Product Change Notice (PCN)

PCN Number: **PCN-0454905R-01**

Product(s) Affected: *PJ-079BH*

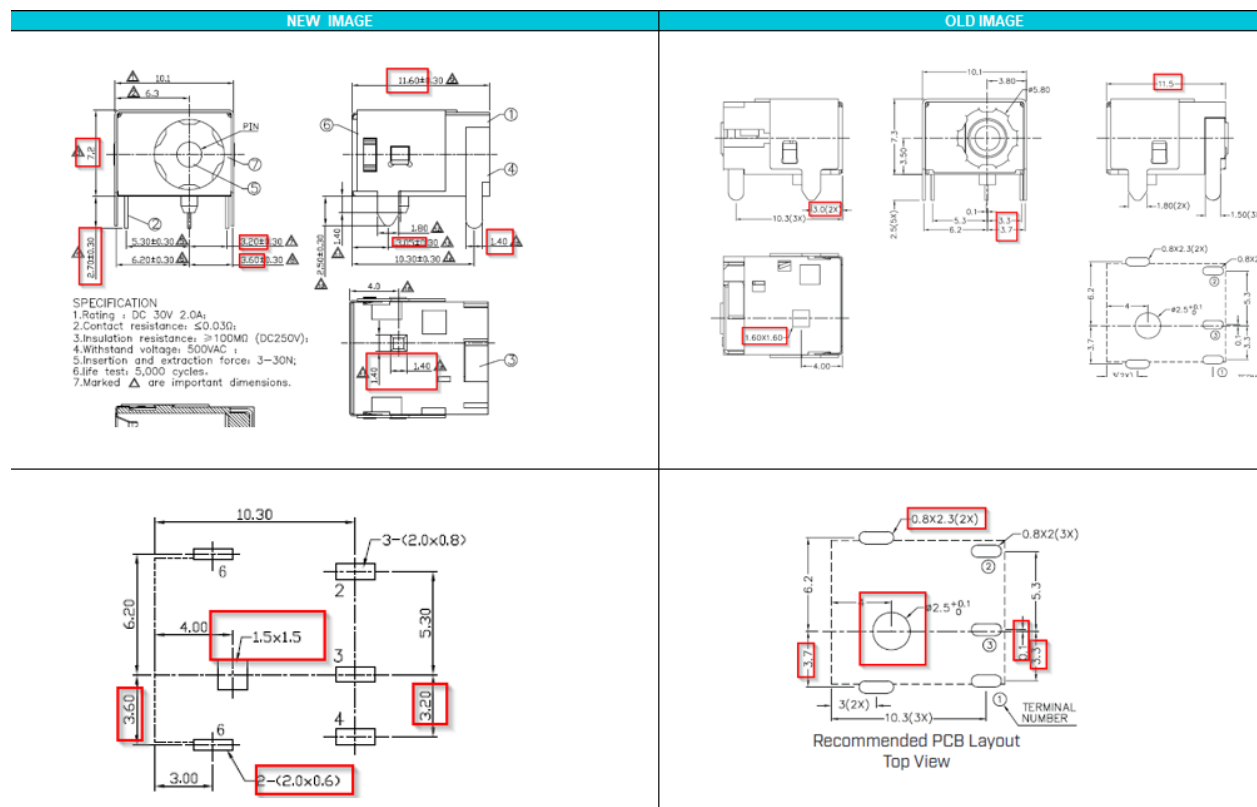
Description of Change: *Minor Housing and footprint differences. Material Change on the housing and terminals. See image Below*

Housing and Terminal Material Changes:

Center Pin: Copper to Brass
Terminal 2: Copper Alloy to Brass
Plastic: PA6T or Equivalent to PA9T
